REQUEST FOR BIDDING INTERPRETATION (RFBI)

PMDB RFBI No.: 01

Project No.: 000000000009324

Project Name: OES Security Upgrades

Drawing Reference: A401,A402 Project Manual Reference: 13 34 23 - 2.3F

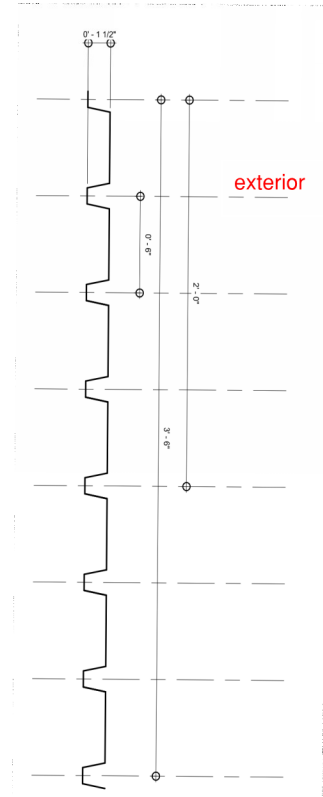
Question: Spec section 13 34 23 2.3F calls for a meta

I panel wall system with a special profile. Can you please provide a complete cross section detail illustrating the profile of the architectural metal panel as it interfaces with the wall system?

The guard booth manufacturer will provide and connect the metal panels to the guard booth.

Profile is 6" o.c. box with 1 1/2" depth, 42" Tall, Length varies.
